St. Modwen Developments

Coed Darcy

RE: TRANSPORT RESPONSE

1.6 Coed Darcy - V & V response – SLR Project No 432.001784.00001 – no revision, dated 9th of February 2024

Figure 4: TRICS average external car trip rate per dwelling for different sized sites

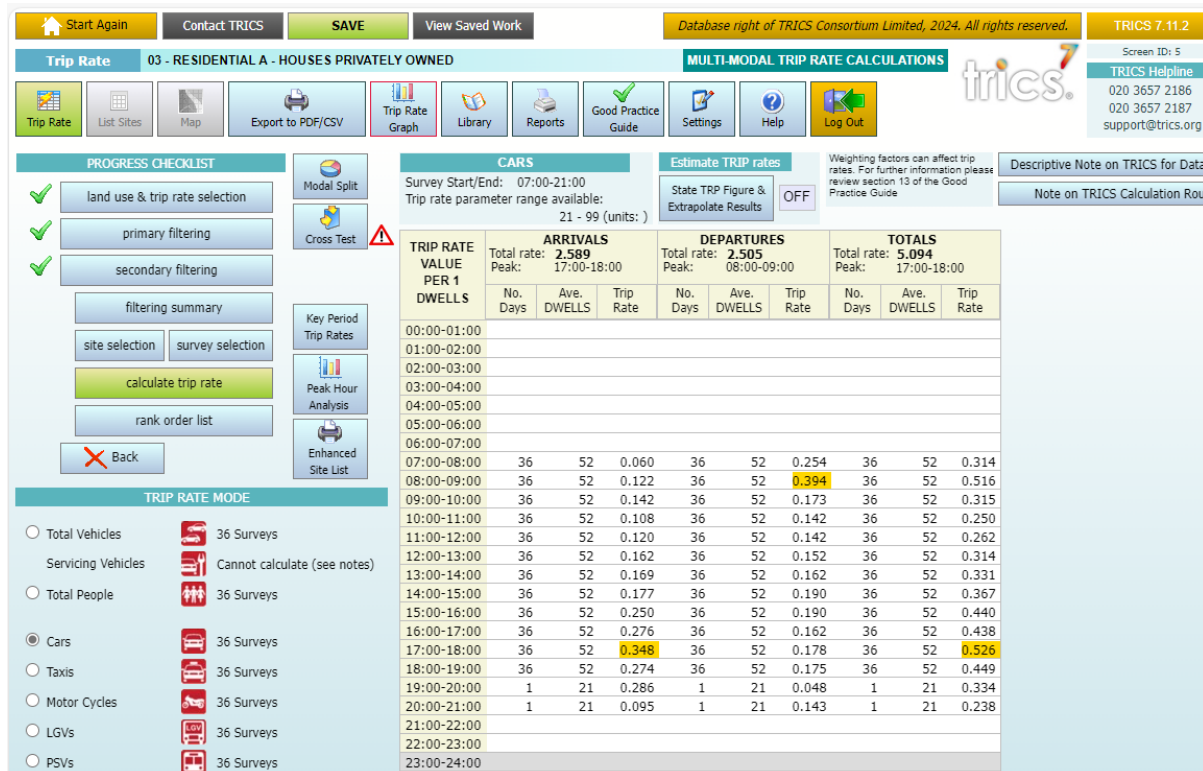
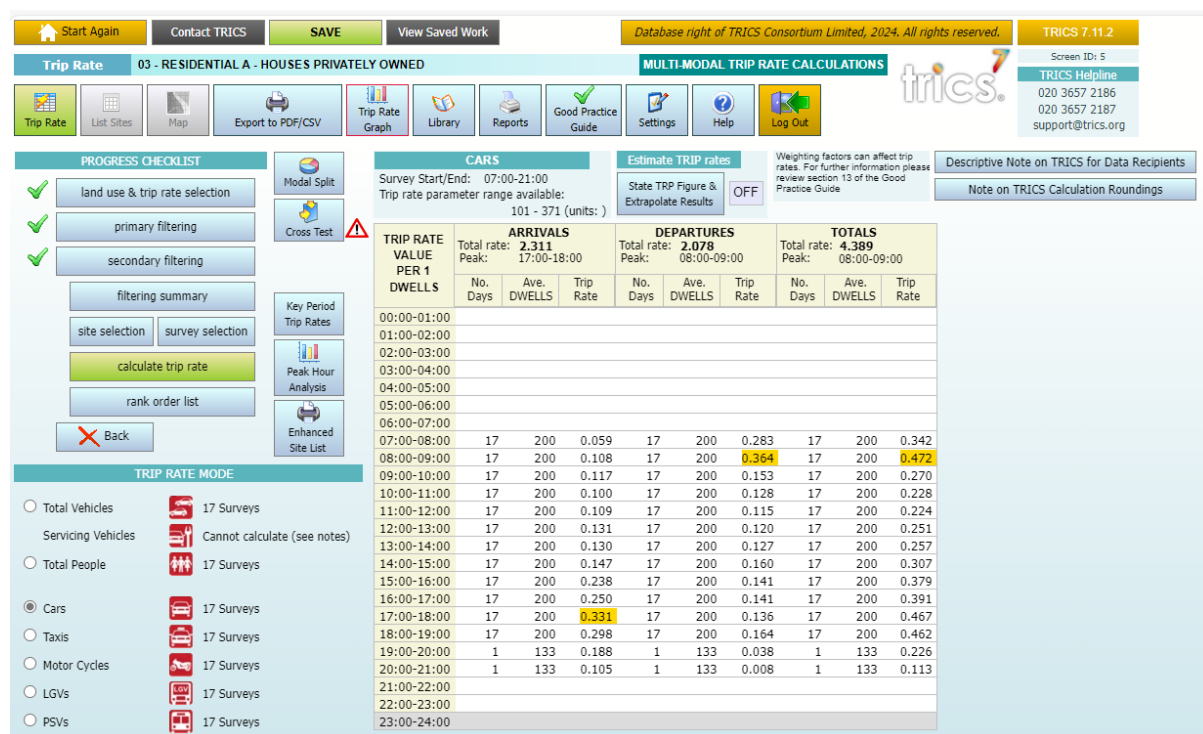
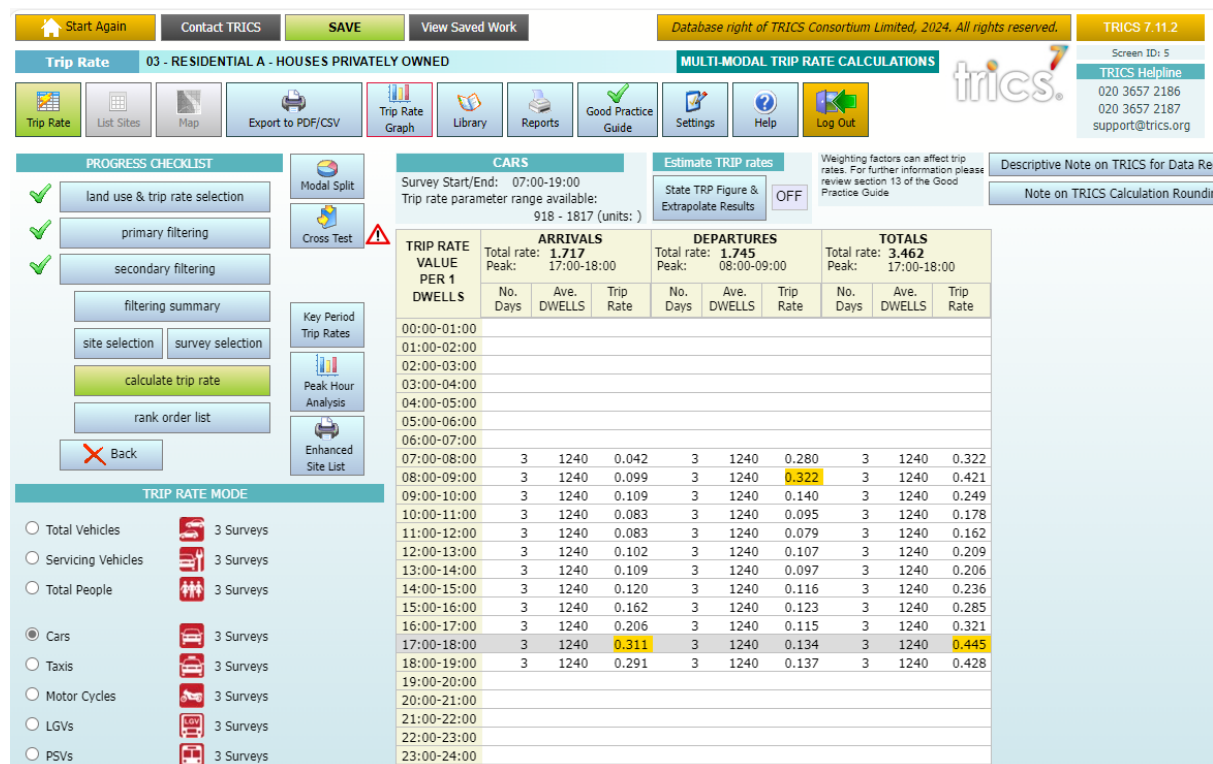
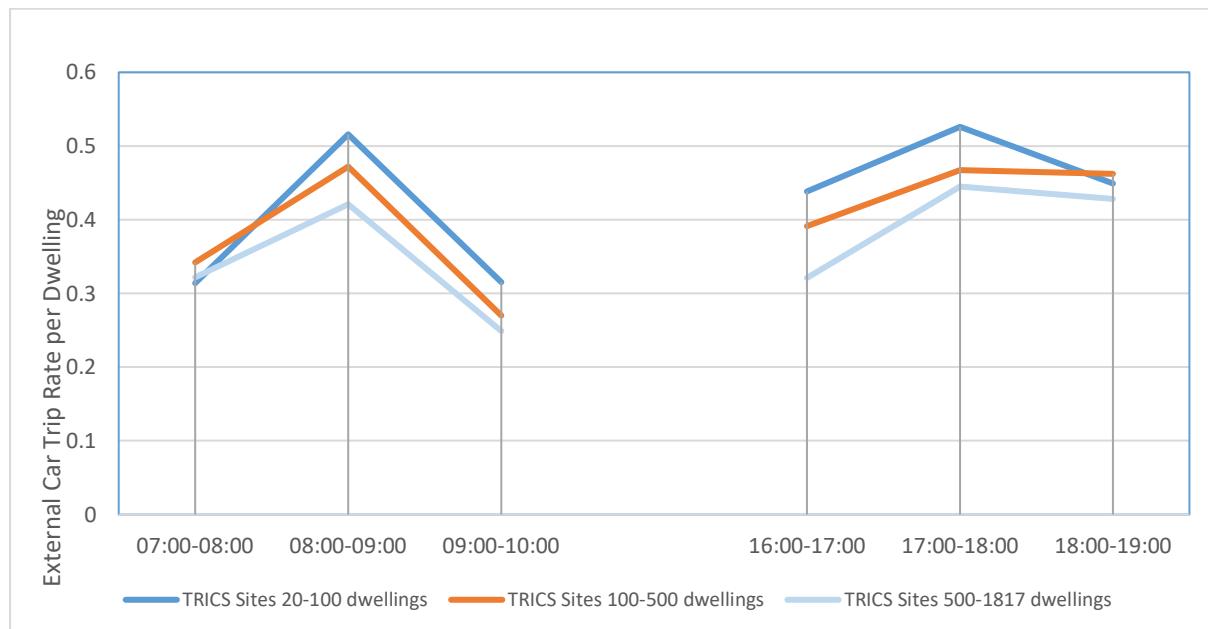
1. **TRICS** data did not cater for this use or size of development, therefore the applicant states *“the forecast of higher number of peak hour vehicular trips leaving the site than would occur in reality”* there is no proof to this statement – awaiting results.

1.8 TRICS contains multi-modal surveys from 56 unique sites in the 03-Residential, A-Houses Privately Owned category (excluding high street and edge of town centre locations) for the 5 year period prior to Covid restrictions (Jan 2015 to Jan 2020).

1.9 Breaking this down into 3 categories of site size, this comprises of 36 surveys at sites with between 20 and 100 dwellings; 17 surveys at sites with between 100 and 500 dwellings; and 3 surveys at sites with over 500 dwellings.

1.10 Figures 1 to 3 shows the average car trip rate per dwelling derived from TRICS for 03-Residential, A-Houses Privately Owned sites in each of the three categories of site size. Figure 4 presents the TRICS peak hours car trip rates per dwelling for each size category of site.

- 1.11 Figure 4 shows the clear trend, from surveyed TRICS sites, that external car trip rates decrease as site size increases. This is due to more trips remaining internal to the site as site size increases, linked in large part to the increases in on-site amenity provision as sites become larger. Trips to these internal amenities replacing trips that would otherwise be external.
- 1.12 To illustrate this further, Figure 5 presents the external car trip rate per dwelling for each of the three 03-Residential, A-Houses Privately Owned sites in the TRICS database with over 500 dwellings.

Figure 7 Plot of NTS data on mode share against distance for shopping trips

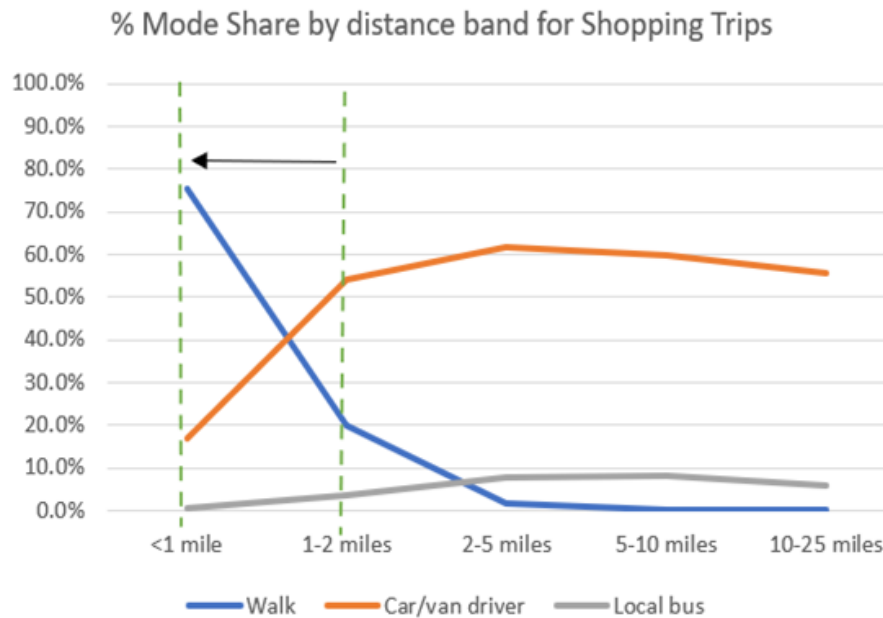
2. **Point 1.8** states the “*national travel survey data was adjusted to refer the mix of household types and local condition*” – How did the applicant ‘adjust’ the data and could they provide raw data so that we may see why consultants had arrived to this conclusion and question the validity of this comment/data.

- 1.28 The third adjustment to the NTS base data is made to reflect the proximity of existing amenities in the local area surrounding the Coed Darcy development. The NTS base data indicates that mode share to an amenity changes markedly with distance - especially for shorter distances. This is illustrated in Figure 7 below plotting NTS data on mode share

against distance for shopping trips and illustrating the significant shift in mode share, primarily from car driver to walk, as distances are reduced from 1-2 miles to under 1 mile.

- 1.29 This highlights the importance of taking into account the distances from the proposed Coed Darcy site to existing amenities external to the site in order to reflect the locally relevant mode share for each trip purpose. The road or footpath distance from the centre of the Coed Darcy site to the closest existing amenities are shown in Table 2.

Figure 10 Active Travel Scheme

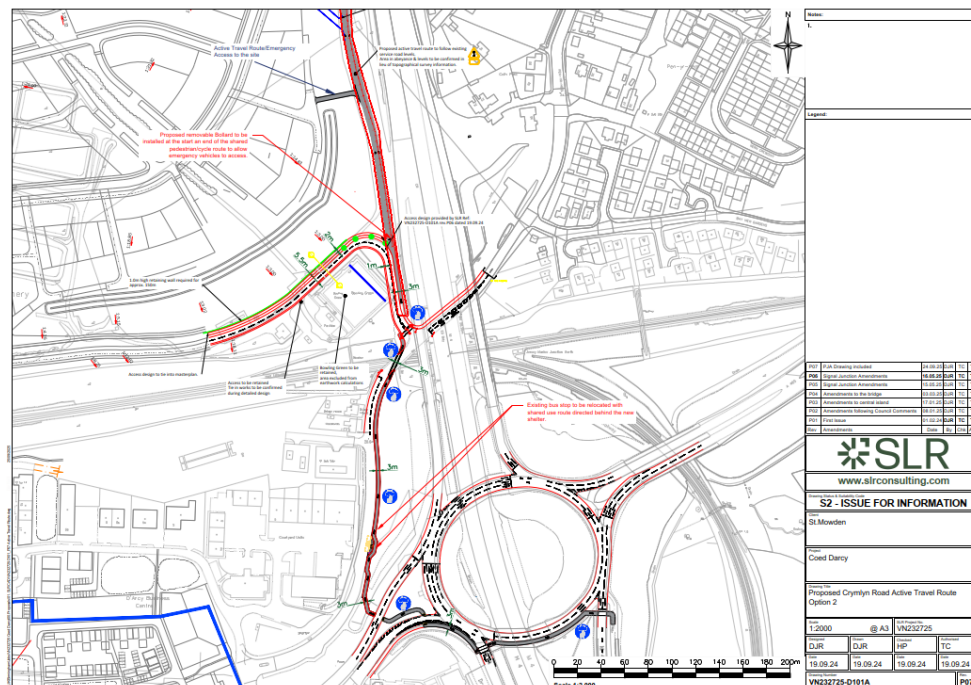
- Formal response to NPTC Vision & Validate comments dated 9 February 2024;
 - Formal response to Swansea Council comments, not dated;
 - Active Travel improvements between the site and Crymlyn Road via Pen-Y-Heol/B4290 and the existing footway/cycleway adjacent to the M4.

- 1.81 The scheme drawing is provided in Drawing No. VN232725-D101A P07 which is replicated below in Figure 10 and provided in **Appendix B**.

- 1.82 The junction capacity analysis has been updated to take account of the revised geometry and the increased crossing times required.
- 1.83 The LINSIG results are provided in Table 4 and the LINSIG output files are provided in **Appendix C**. The results are for the future assessment year of 2026 and are based on the November 2021 Transport Assessment trip generation and distribution. It does not take into account the reduced traffic flows to reflect the Vision & Validate approach and is therefore robust.

- 1.84 The junction capacity results show that the junction works well within capacity with a maximum degree of saturation of 70.3% in the PM peak hour. This assumes the shared pedestrian/cycle crossing and the crossing across the site access are called every cycle on a 90 second cycle time but this would revert to a 60 second cycle time if there was no pedestrian or cycle demand.
- 1.85 It is therefore concluded that an appropriate active travel link can be provided to Crymlyn Road, prioritising active travel movements whilst still maintaining acceptable junction capacity.
